**City of Portland, Maine – Building or Use Permit Application** 389 Congress Street, 04101, Tel: (207) 874-8703, FAX: 874-8716

Location of Construction: 1053 Forest Ave		Owner: John LaFevre		Phone: 797-4838		Permit No: 990100	
Owner Address: 72 Auburn St Portland 04103		Lessee/Buyer's Name:		Phone:		BusinessName:	
Contractor Name: SAA		Address:		Phone:			
Past Use: Retail		Proposed Use: Karate Studio		COST OF WORK: \$ 15,000		PERMIT FEE: \$ 95.00	
				FIRE DEPT. <input checked="" type="checkbox"/> Approved <input type="checkbox"/> Denied		INSPECTION: Use Group: / Type:	
Proposed Project Description: Interior Renovations/Change of Use				Signature: <i>[Signature]</i>		Signature: <i>[Signature]</i>	
				PEDESTRIAN ACTIVITIES DISTRICT (P.A.D.)		Zoning Approval:	
				Action: Approved <input type="checkbox"/> Approved with Conditions: <input type="checkbox"/> Denied <input type="checkbox"/>		Special Zone or Reviews: <input type="checkbox"/> Shoreland <input type="checkbox"/> Wetland <input type="checkbox"/> Flood Zone <input type="checkbox"/> Subdivision <input type="checkbox"/> Site Plan maj <input type="checkbox"/> minor <input type="checkbox"/> mm <input type="checkbox"/>

DATE: 10

PLOT PLAN FOR 1053 FOREST AVE.

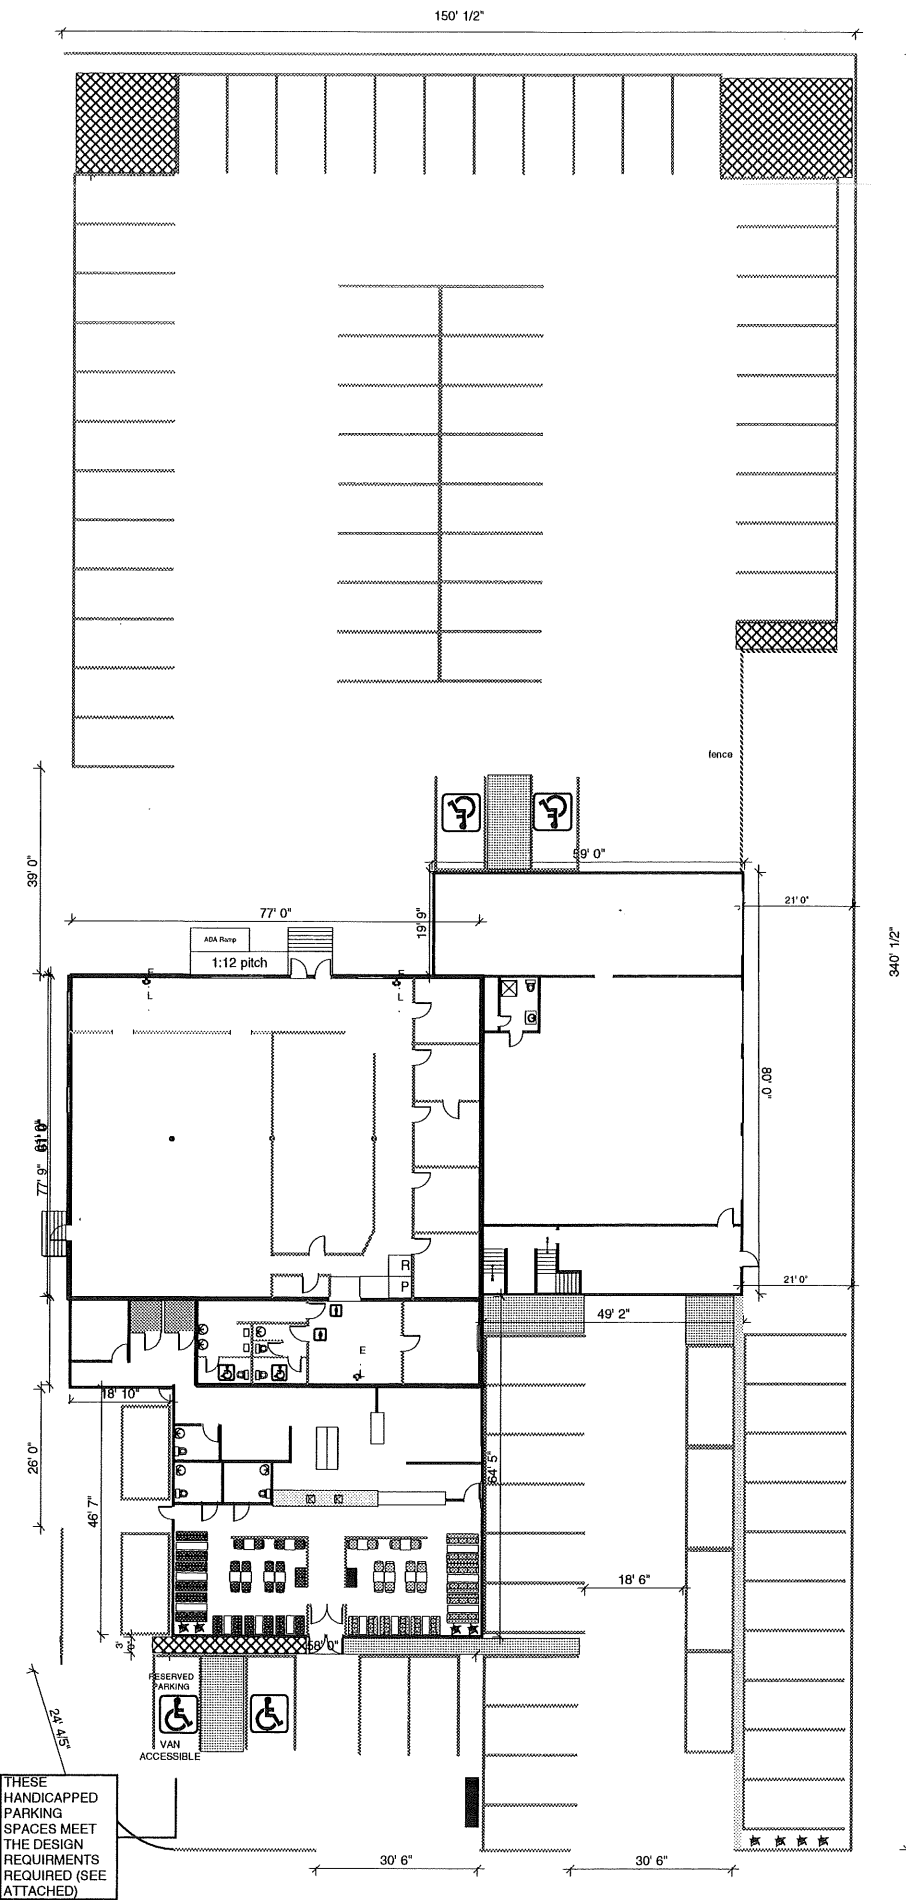
② MARGE Schmuckel will need  
A NEW PLOT PLAN showing property  
Boundaries on Bell ST side of  
Structure & location of new STAIRS  
in relationship to Property line

PLOT PLAN FOR 1053 FOREST AVE.

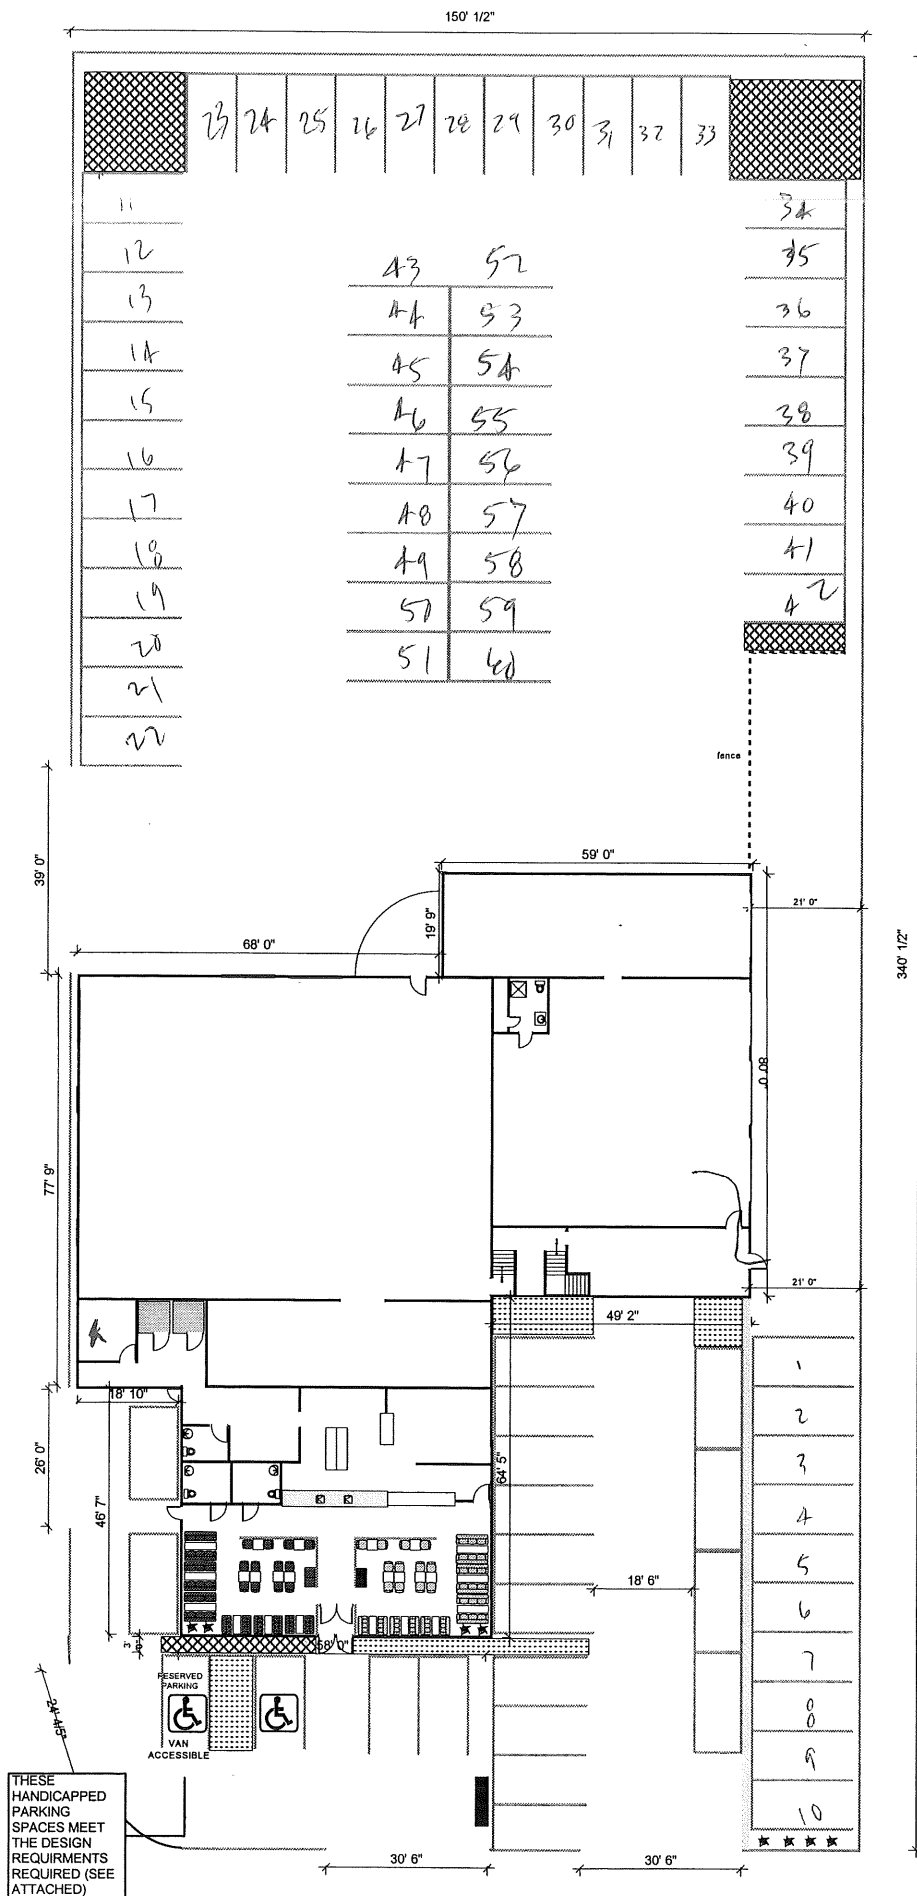
Do we have a  
Dead-end Travel problem?
